Informal Document No.
(41st GRSP, 7-11 May 2007,
agenda item 3.1.1.)

ECE/TRANS/WP.29/2007/47/[revised](#)
13 April 2007

Proposal for a draft global technical regulation concerning head restraints

Submitted by the Chairperson of the Working Party on Passive Safety

Figure 1-2

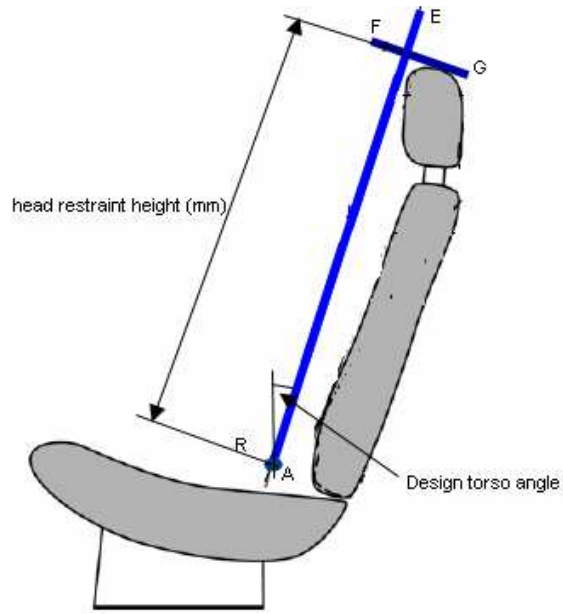
Comment [sm20]: Alliance recommendation. Check minutes, I think this was agreed on.

Figure 3-2

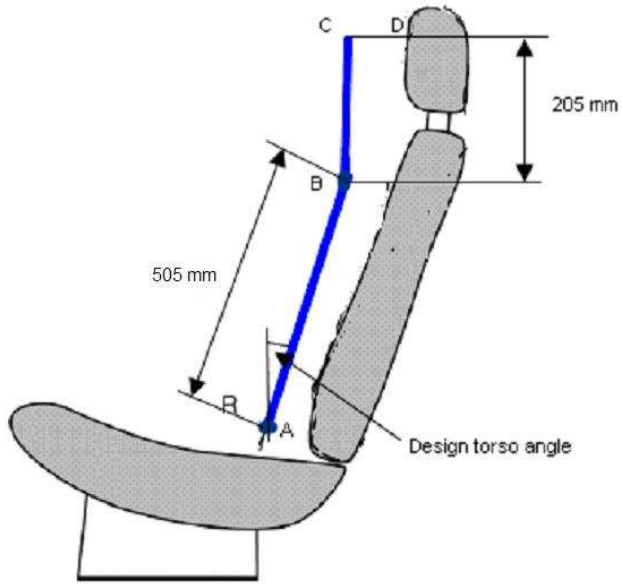
Comment [sm22]: Verify the diagram reflects the text. Change 505 to 504.5, change 205 to 203, change design torso angle to design torso angle less 2.6 degrees.

Figure 4-3

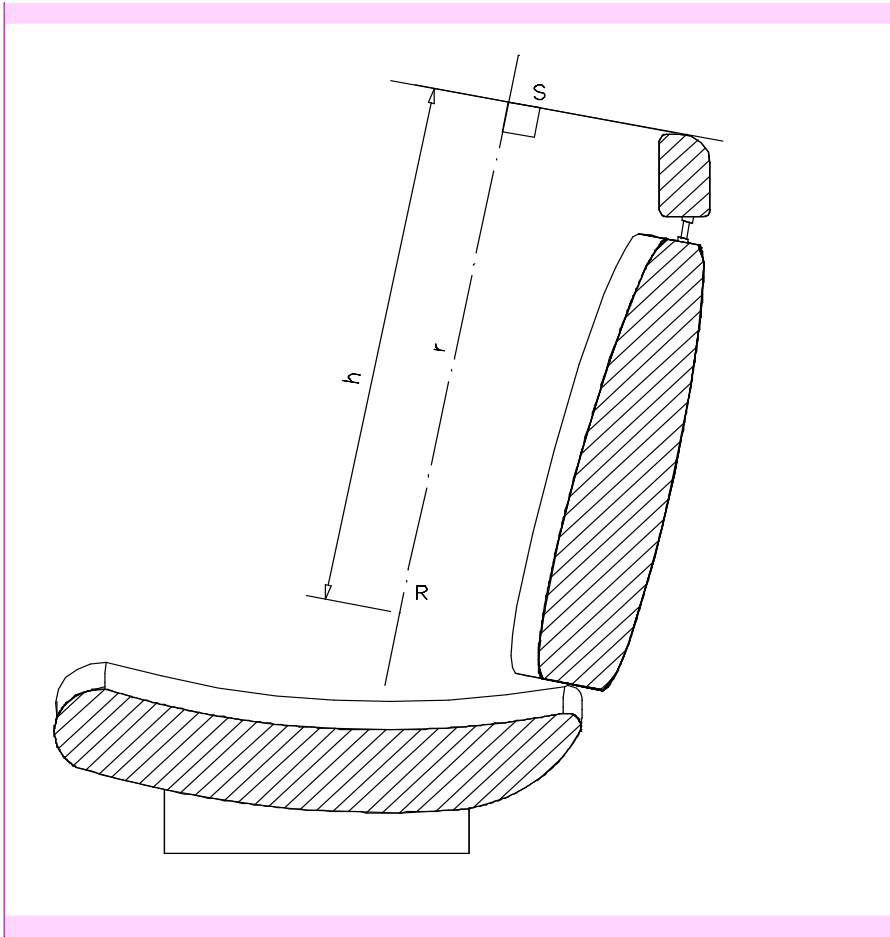
Comment [sm23]: Add dimension lines
